**SUPPLEMENTAL CORRECTION SHEET FOR THE BASELINE HILLSIDE ORDINANCE (BHO)**

(Ordinance No. 184,802 Effective 01/01/2023)

This is a supplemental correction sheet. Please see the attached master correction sheet.

**Figure 12.21 C.10(a): Plane break diagram**

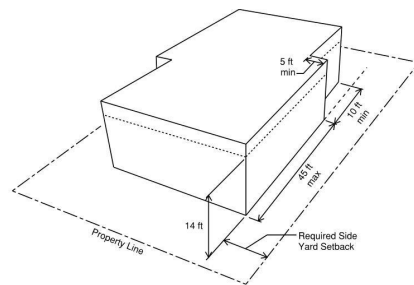
3. In the R1 zone, where the Building or Structure has a side wall that exceeds a height of 14 ft. and has a length of 45 ft. or more, provide an offset/plane break that has a minimum depth of 5 ft., beyond the required Side Yard setback, for a minimum length of 10 ft. (*Table 12.21C.10- 1*). See below for Example Figure 12.21 C.10(a).

**Figure 12.03-1: Encroachment Plane diagram**

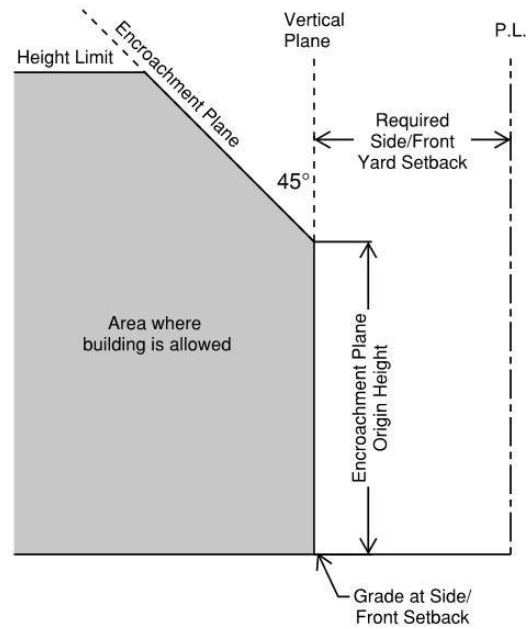
5. Show that all Buildings and Structures in the R1 zone do not exceed the Encroachment Plane Height with an Encroachment Plane Origin Height of 20 ft. and Encroachment Plane angle of 45° measured from existing or finished grade whichever is lower. See Figure 12.03-1 to the right.
